Access Compliance Report Public Rights-of-Way (Curb Ramps)

Main Street: FOSTER_RD Cross Street: ACECA_DR Location: E

ADA ID: RPRK211216131230 Ramp Type: Type 1 - Perpendicular Diagonal Initial Pass/Fail: Pass Overall Compliance: No Severity Score: 2

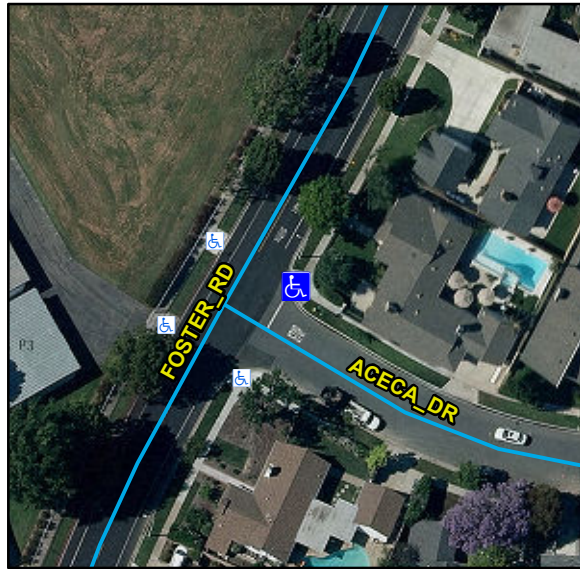
Gutter Ponding Observed.

Crossing 1 Slope (%)	6.3		Crossing 2 Slope (%)	3.7
	Crossing 1 Cross Slope (%)	0.4		Crossing 2 Cross Slope (%)	0.3
No	Gutter Ponding	Yes	Yes	Curb Slope	2.2
Yes	Gutter Lip Height (in)	0		Road Run Slope (%)	2.3
Yes	Gutter Run Slope (%)	4.7		Road Cross Slope (%)	4.6
Yes	Gutter Cross Slope (%)	0.1			
Yes	Overall Surface Condition: Acceptable		Yes	Perp Joint Present	Yes
	Cross Gutter Present?	No		Spandrel Present?	No
	Replace Cross Gutter?	N/A		Replace Spandrel?	N/A

Possible Solutions:

R302.7, STD 1115
